SECTION 2 Elevations _ Block 02 South-East elevation

SECTION 3 3D views

SECTION 4 Approved and Proposed Drawings Schedule

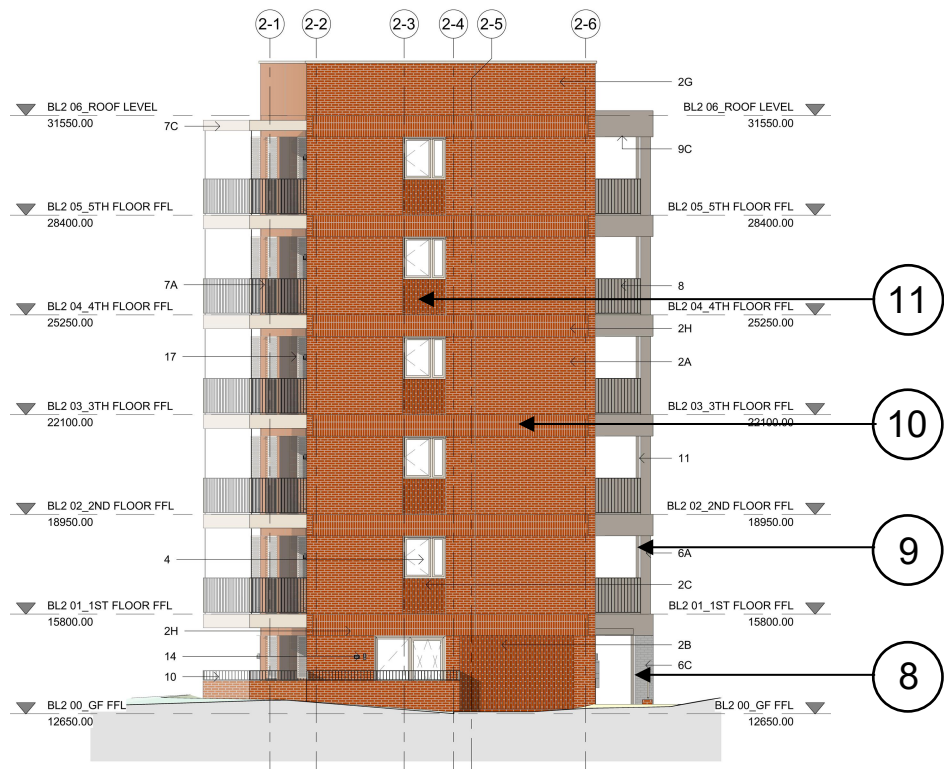
- 8. Ground floor external columns clad in Ibiza white brickwork.
- 9. Aluminium metal cladding to external columns at inset balcony corner and external walkways in upper levels.
- 10/11. Brick coursing at window interfaces.

SECTION 2 Elevations _ Block 02 North-East & South-West elevations

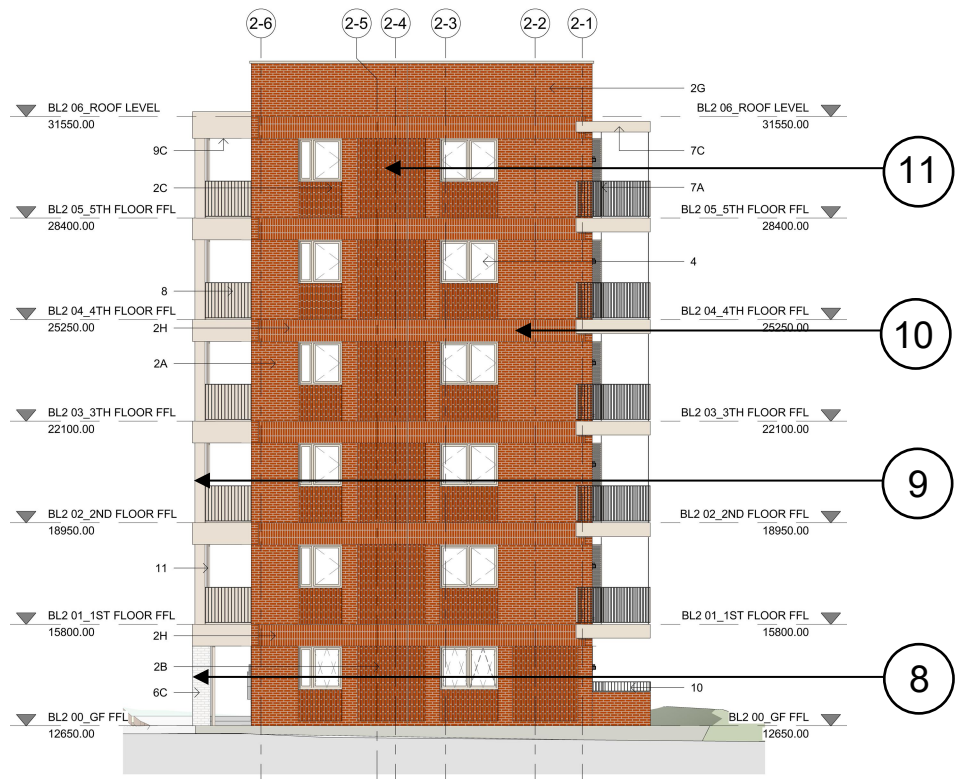
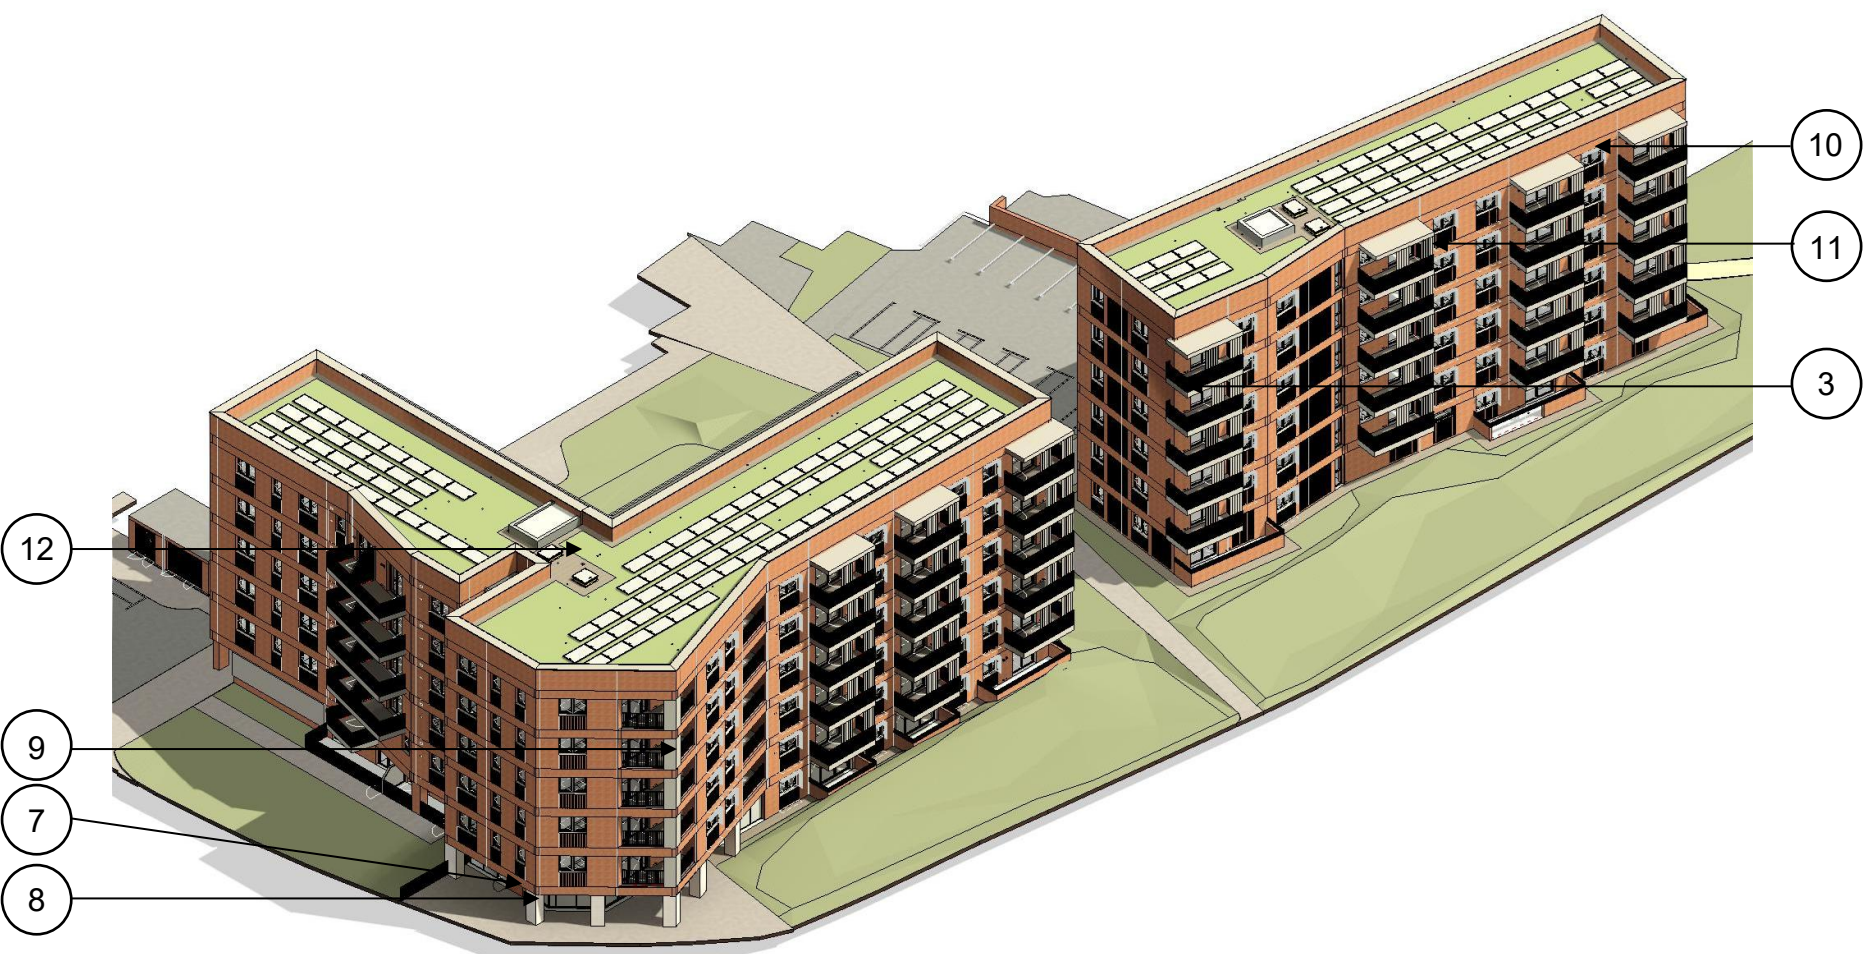
- 8. Ground floor external columns clad in Ibiza white brickwork.
- 9. Aluminium metal cladding to external columns at inset balcony corner and external walkways in upper levels.
- 10/11. Brick coursing at window interfaces.

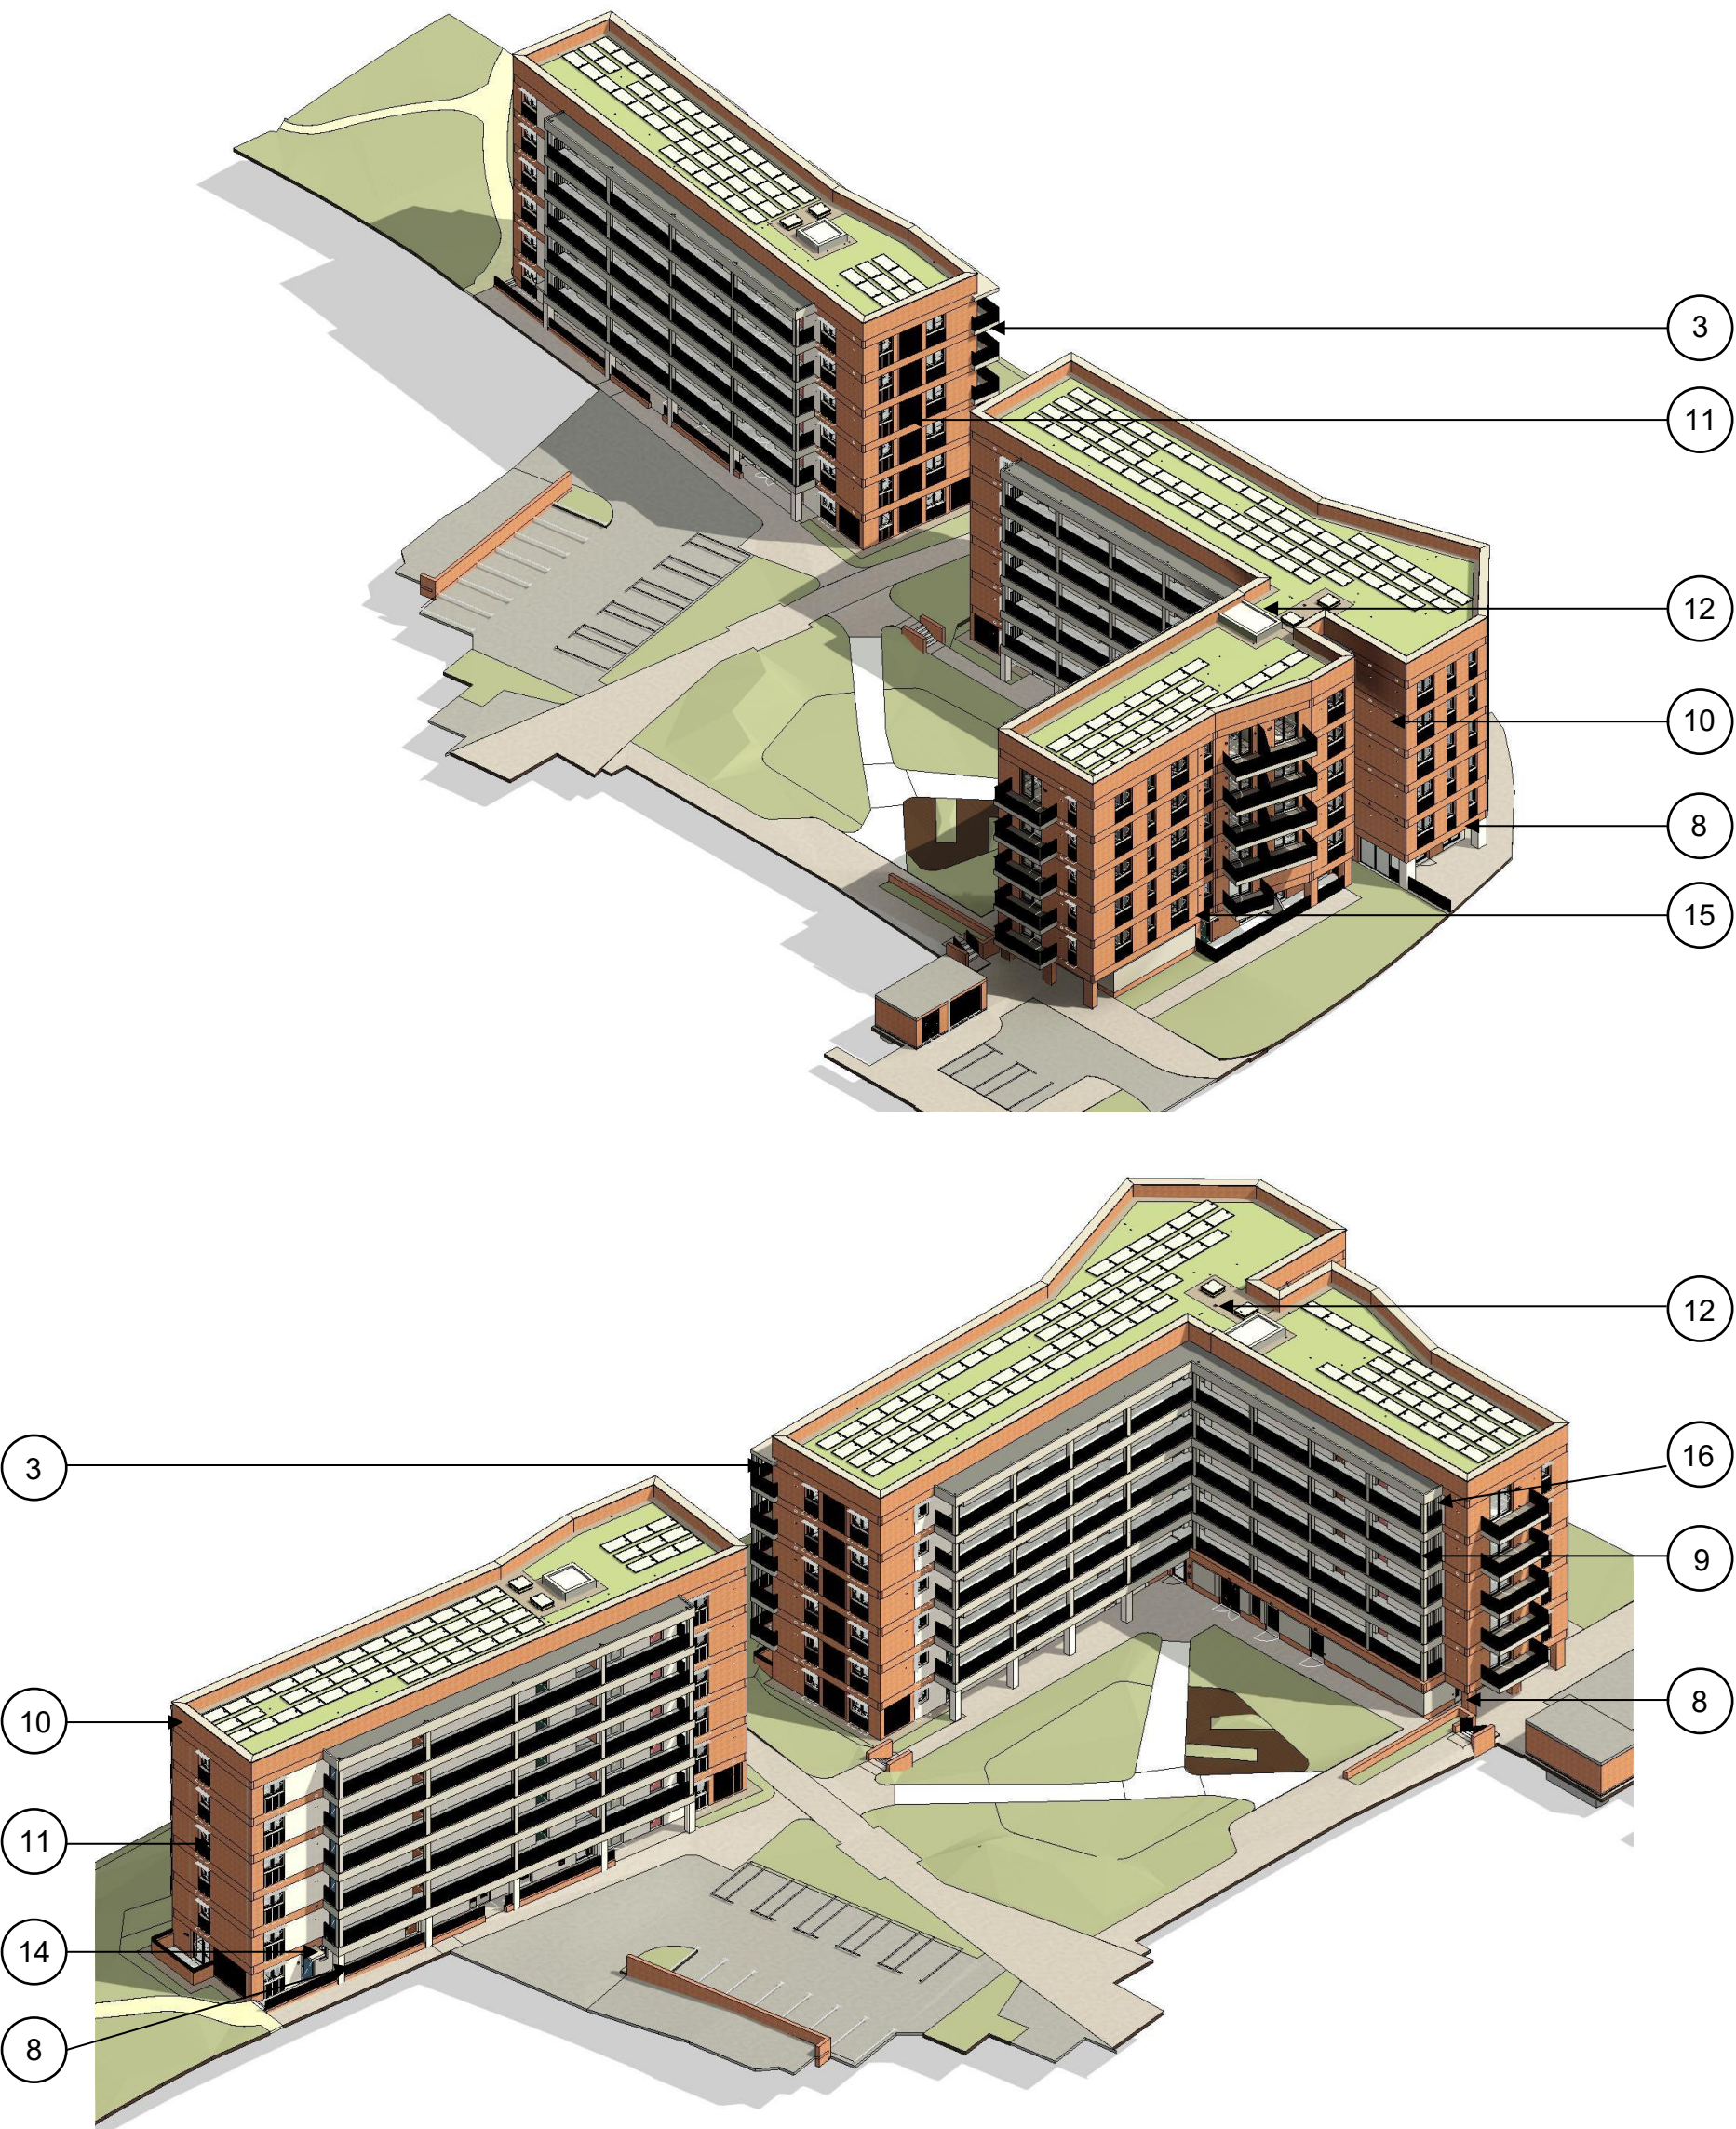
- 3. Corner bolt-on balconies cantilevered reduction.
- 7. Main entrance brick pier for panelling and services installation.
- 8. Ground floor external columns clad in Ibiza white brickwork.
- 9. Aluminium metal cladding to external columns at inset balcony corner and external walkways in upper levels.
- 10/11. Brick coursing at window interfaces.
- 12. Roof bridge removed.
